INITIAL FIRE SAFETY INSPECTION REPORT

DMC Apparels Ltd

RSC ID: 26420

Date: 04-November-2025

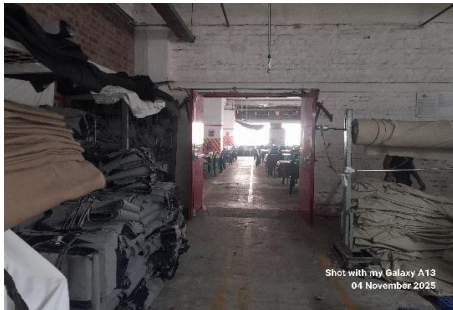
F-15	Means of Egress	A single means of exit has been provided on 2nd floor of the interim construction. Location: 2nd floor of the north-east side, Block-J.	The number of means of egress from any floor, story or portion thereof shall not be less than 2 except where a single exit is permitted by RSC Technical Guideline (Standard), section 6.6.2. Provide additional exit and ensure that the exit doors or means of egress openings are located a distance apart as per RSC Technical Guideline (Standard) section of 6.6.6.	Within 3 Months
